TRANSPORT NOTE

Land Adj' 12, Newquay Close, Hinckley
Leicestershire.

Change of Use of land to 4No Gypsy / Traveller
pitches with associated infrastrcure.

Previous Planning Application No: 23/00655/FUL

Figure 1: 1km & 2km Pedestrian Isochrones

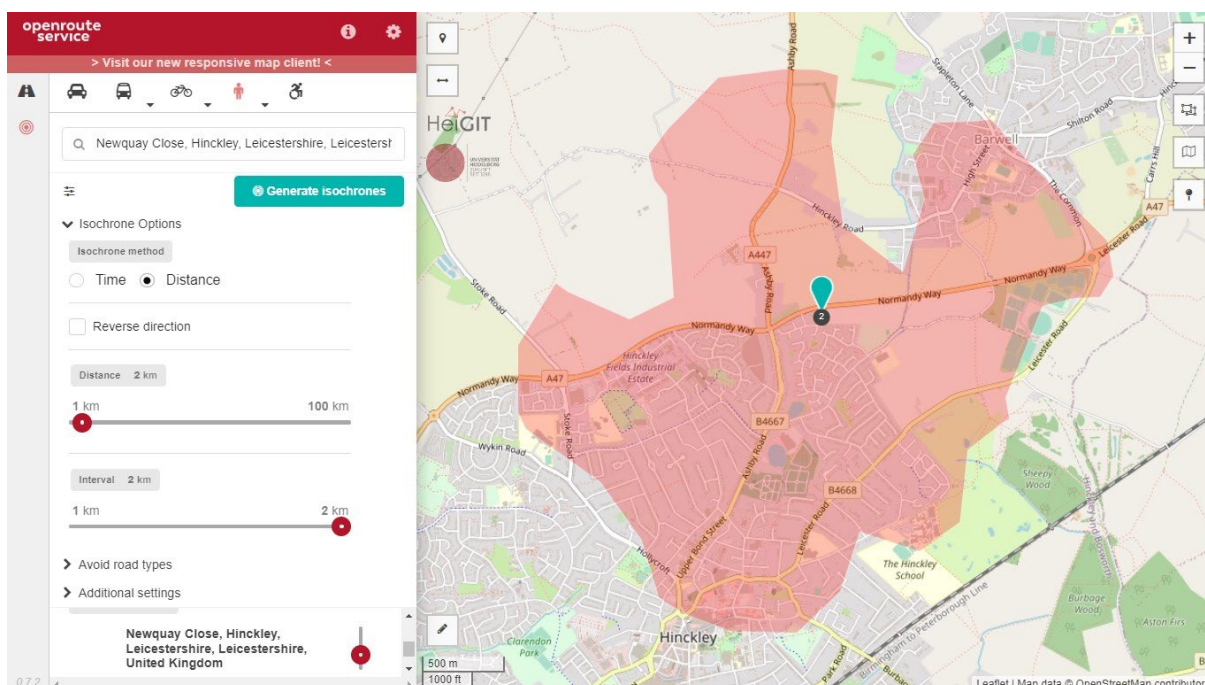
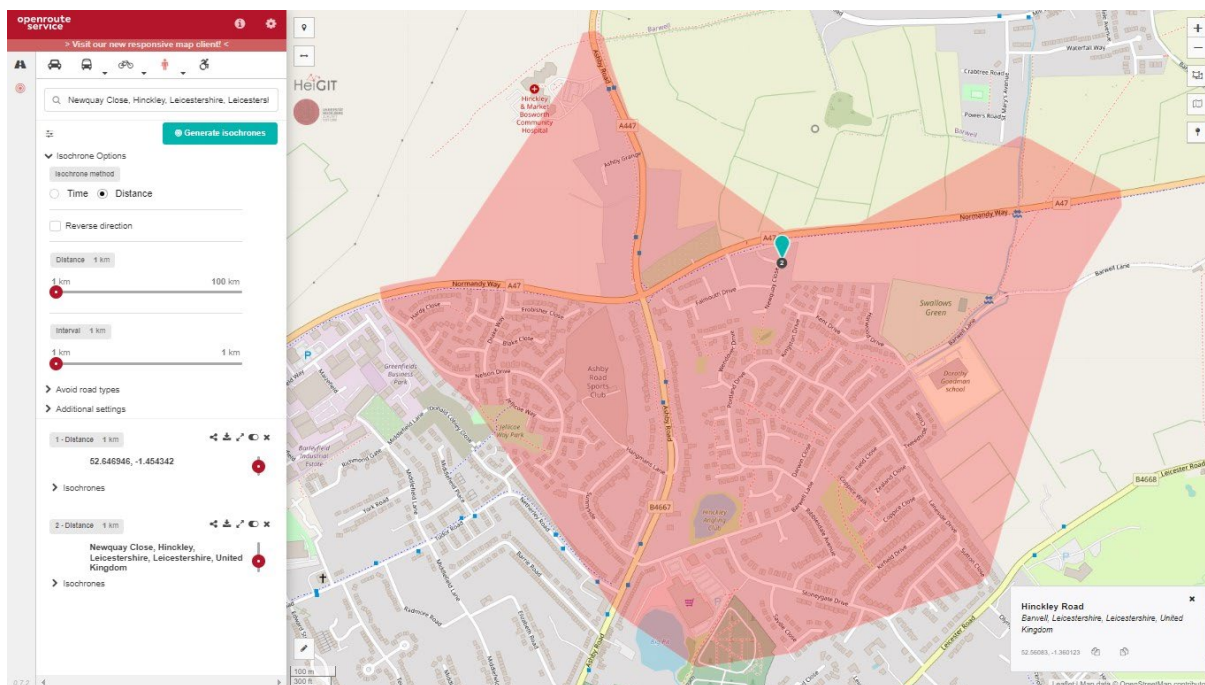
The site is an approximate 690m walk from bus stops served by regular bus services between Nuneaton and Leicester, however other facilities such as a convenience store and schools are over a 1 km walk.

2.12 The site is supported by continuous footway links providing a connection to nearby services / facilities. The surrounding local footway network does not have an unreasonable topography.

2.13 Guidelines for Providing for Journeys on Foot (Institution of Highways and Transportation 2000) suggests that for commuters and school pupils without mobility impairment walking to local amenities, up to 500 metres is the desirable walking distance, up to 1,000 metres is an acceptable walking distance, and up to 2,000 metres is the preferred maximum walking distance. Walking accounts for over a quarter of all journeys and four-fifths of journeys less than one mile (1.6km). Figure 1 below identifies both 1km & 2km isochrones for walking from the centre of the site.

2.14 The exercise demonstrates that there are a reasonable amount of local amenities within a 2km walking distance of the site including the following:-

ACCESS DETAILS

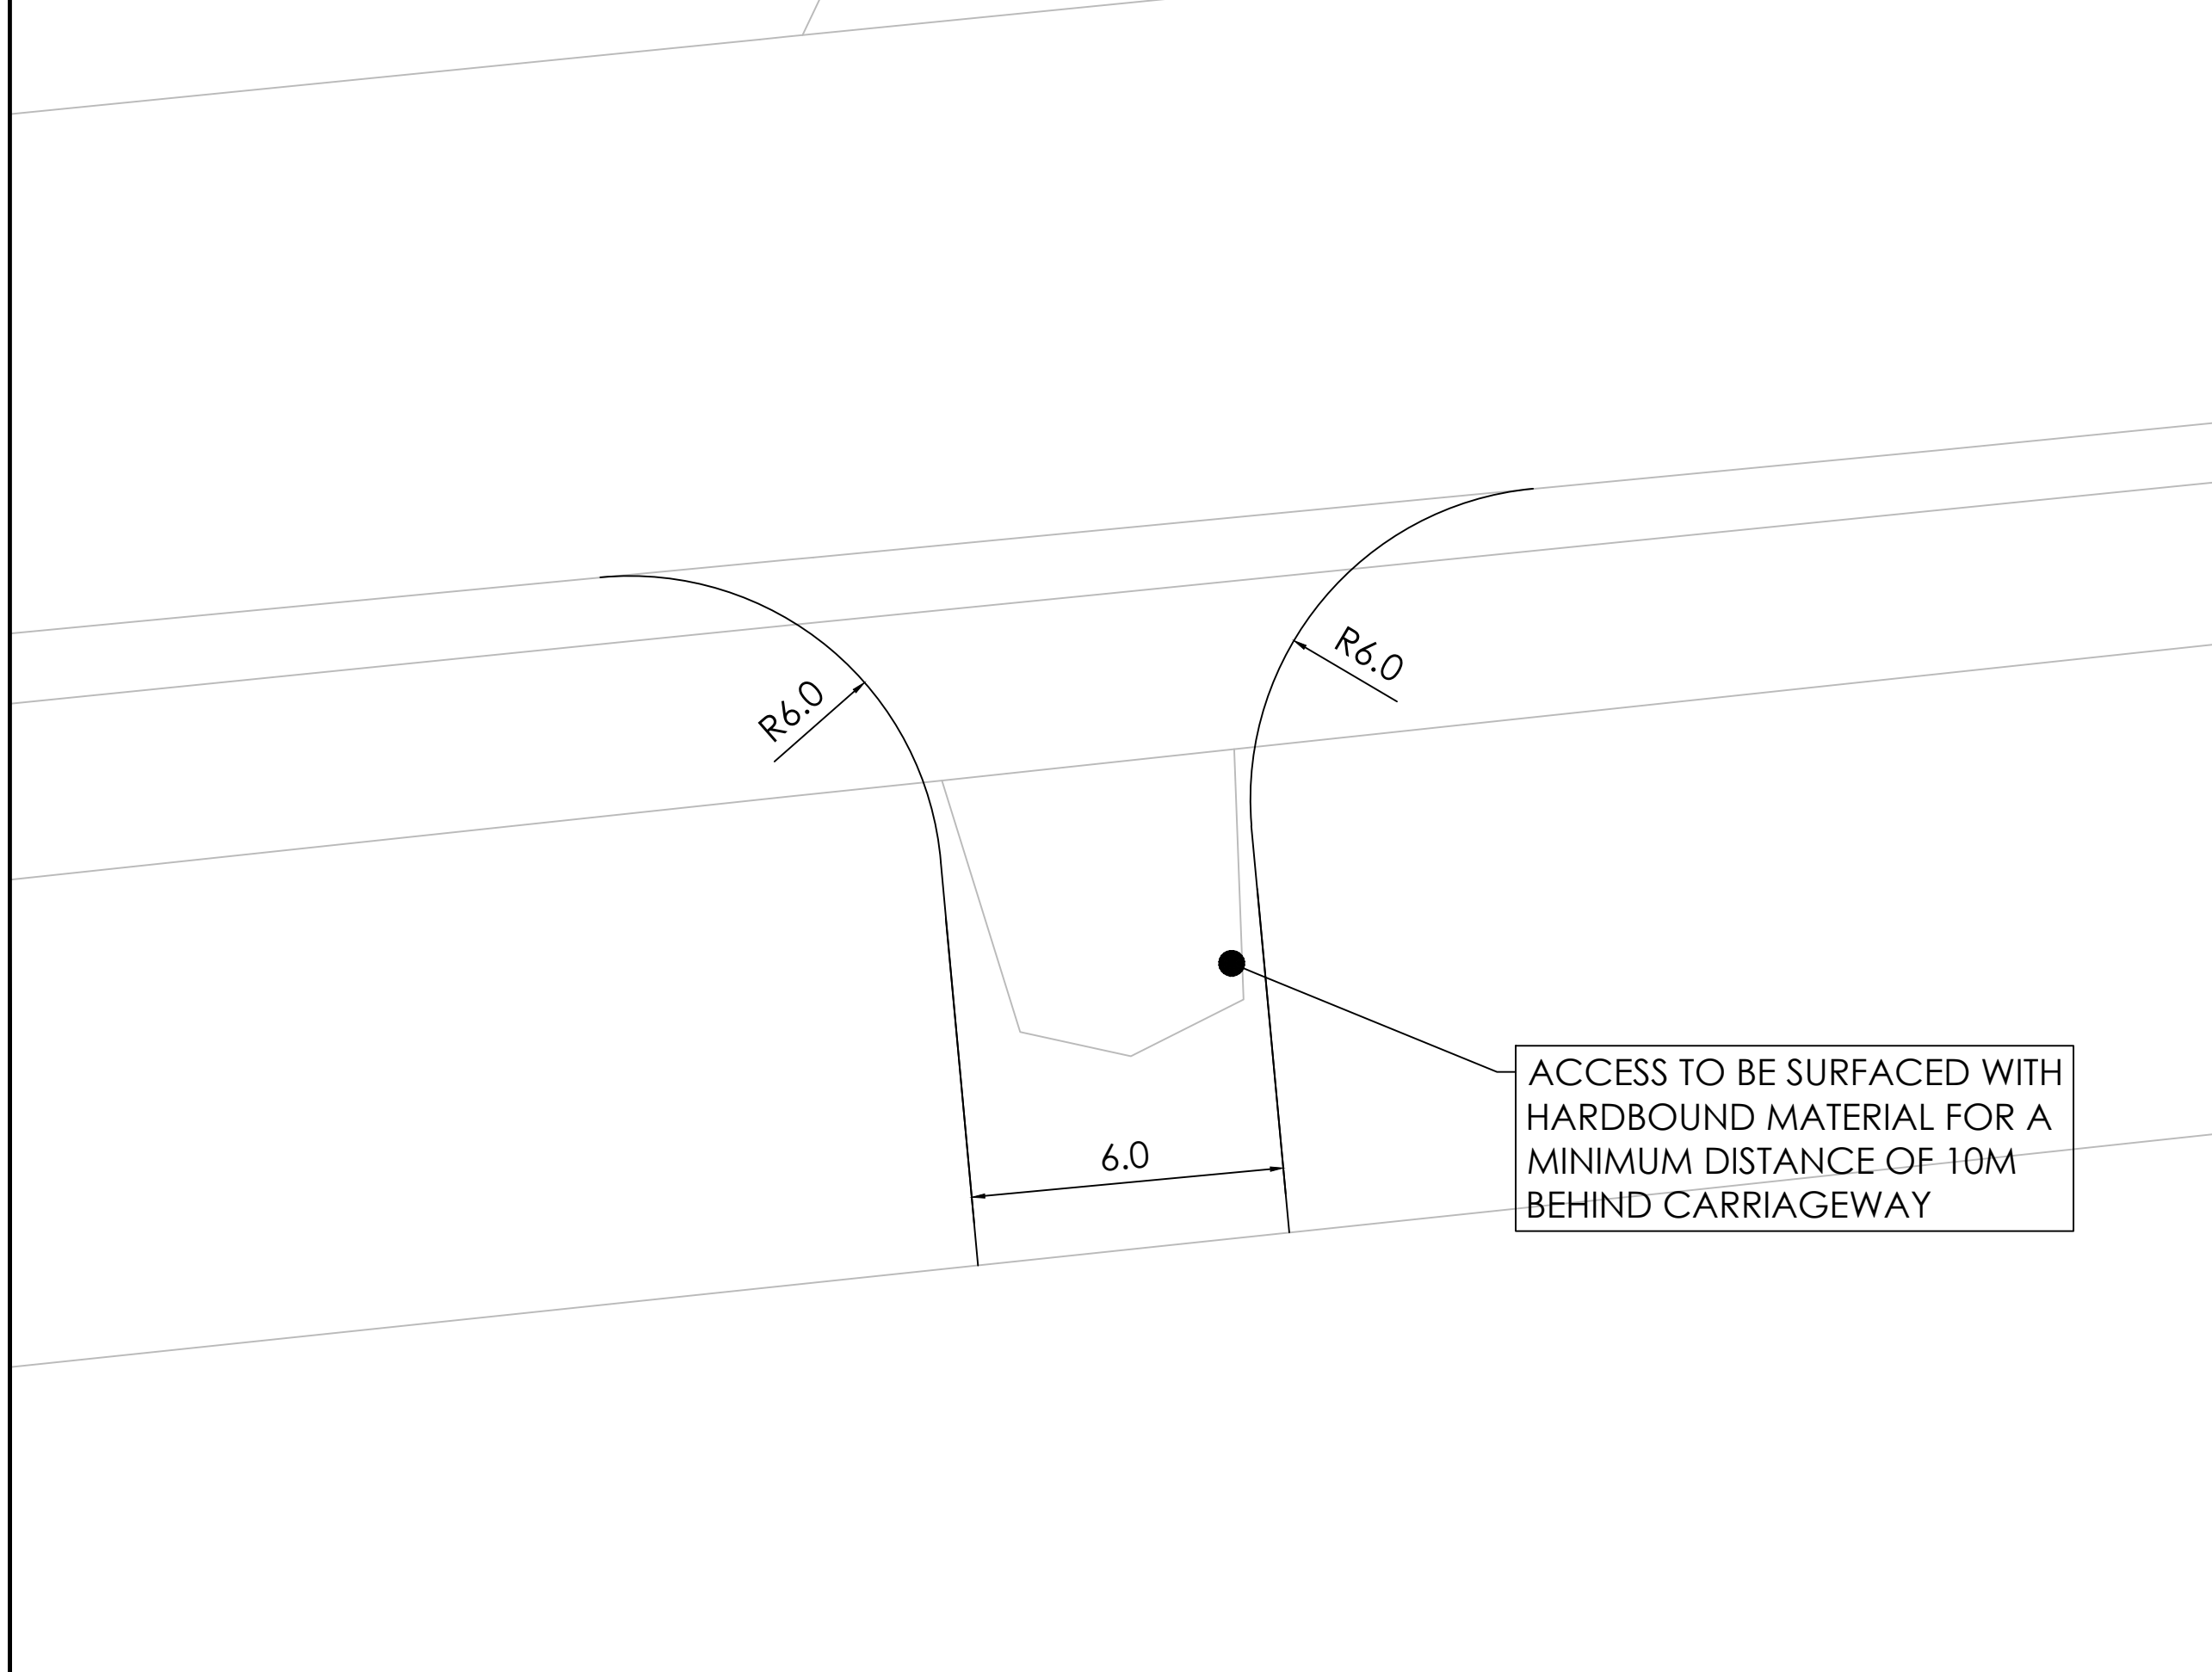
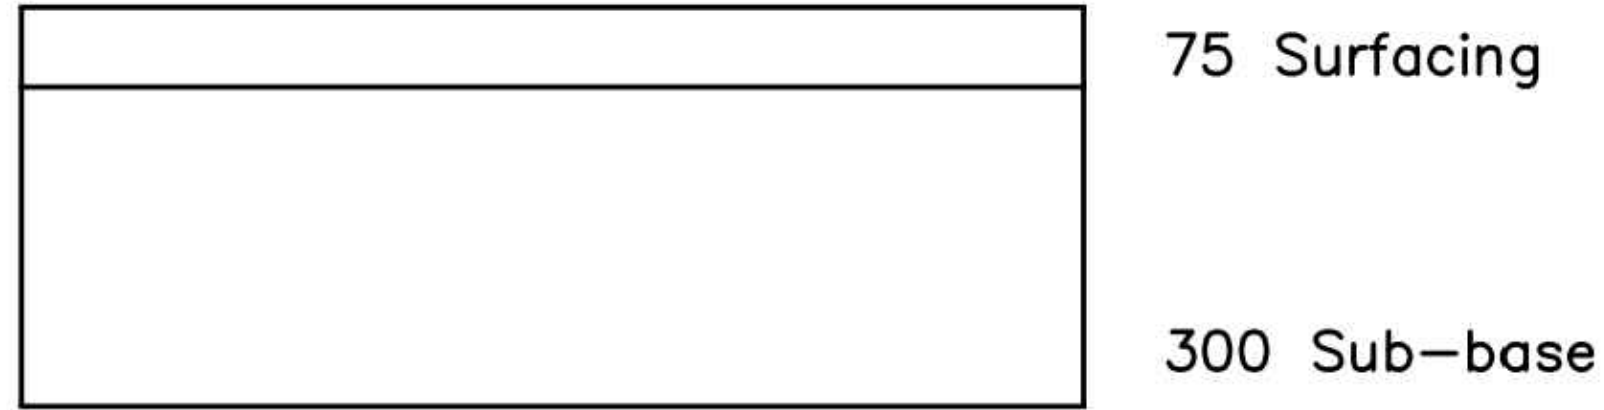
The Applicant has stated that there are no alterations proposed to the existing access arrangements. Based on Kevin Todd Architectural Ltd drawing number 2023031-PL-010, the LHA have scaled that the site access would be approximately 4.30m wide, which is considered to be insufficient to allow two vehicles to pass in the event one or both were towing a touring caravan for example. This could result in a vehicle having to reverse back on to the A47 or wait on the A47 to allow another vehicle to egress the site, to the detriment of pedestrian and highway safety. Furthermore, no details in respect of the available visibility splays or swept path analysis of a vehicle towing a touring caravan for example have been provided.

Therefore, the LHA does not consider that visibility splays based on Manual for Streets requirements would be appropriate, and the LHA would expect the Applicant to provide visibility splays in accordance with Part 3 Table DG4 of the LHDG. This indicates that for a road with a speed limit of 60mph visibility splays of 2.4m x 215m would be required if vehicle speeds are commensurate with the speed limit. The Applicant has not shown this is achievable or provided any evidence from an up-to-date speed survey that recorded 85th percentile speeds are lower, which could justify reduced visibility splays.

In accordance with the LHDG, based on the recorded 85th percentile speeds, the required visibility splays at the proposed site access would be 2.4m x 160m. This is based on speeds of 45 to 53 mph. While the Applicant has not demonstrated these are possible, the LHA considers appropriate visibility should be achievable within the extents of the public highway.

2.7 LTP have produced a vehicular access design drawing which indicates improvements to the current width and geometry of the access. The access has been designed in full accordance with the requirements of the Leicestershire Highways Design Guide and in accordance with the Design Manual for Roads and Bridges. A 6m wide access with 6m radii either side is proposed. Visibility splays have been established from the LHA's speed survey results and plotted onto the drawing. Vehicle Swept Path Analysis has been carried out for a 4x4 vehicle towing a caravan turning at the access. The aforementioned, addresses the LHA access design concerns. **See Appendix B.**

When considering the results, we have carried out calculations based on the methodology contained in the design document 'Manual for Streets II. The calculation sheet is attached at **Appendix C**. Using the DMRB desirable minimum standard of a 2 second reaction time and 2.45m/s deceleration rate then the following splays are required at the access (these are plotted on our access drawing and are the most robust parameters): -

- 2.4m x 146m to the east
- 2.4m x 164m to the west
